# Review 1

## Preliminary and Final Major Site Plan Bayonne Luxury Waterwalk, LLC

219 W. 5<sup>th</sup> Street  
Block 301.01, Lots 1 and 6  
219 W. 5<sup>th</sup> Street Redevelopment Area

April 28, 2023

Preliminary Site Plan Submission (Approved May 10, 2022)

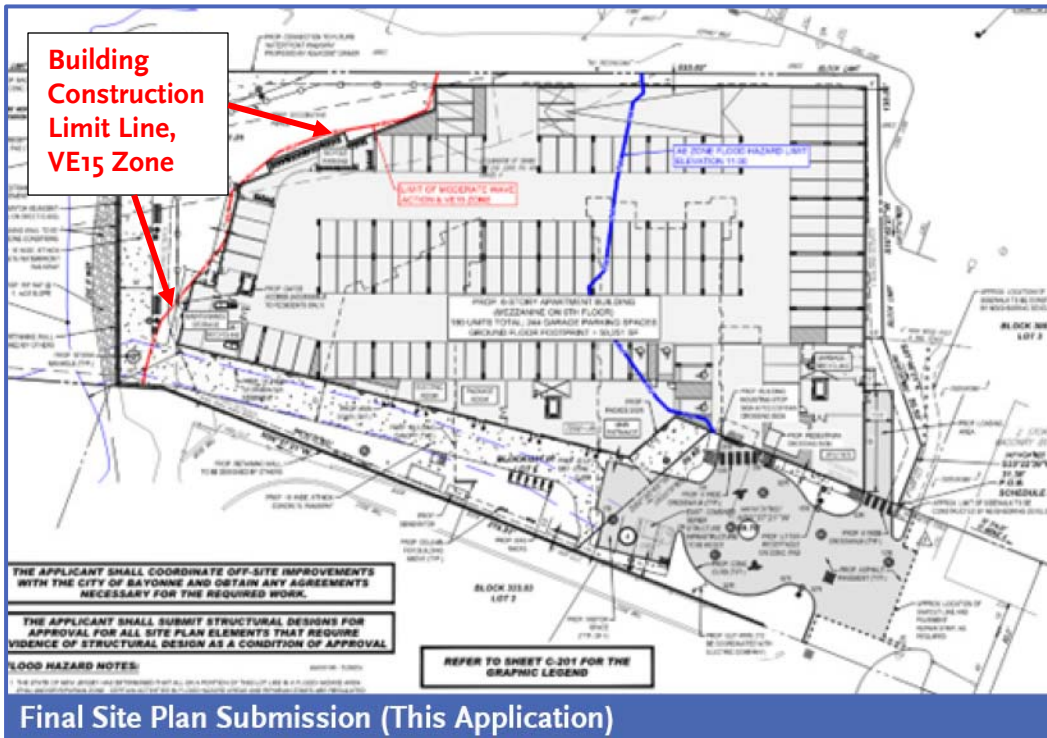
- 1.3. **Changes from Preliminary Site Plan:** There are substantial changes from the approved preliminary plans to the submitted final plans. The most significant changes are to the building footprint, residential unit mix, parking and EV charging layout, site circulation, and landscape plan. Notably, the building footprint and site layout have been revised to accommodate the Limit of Moderate Wave Action and VE15 zone associated with Newark Bay to the west-northwest of the site.
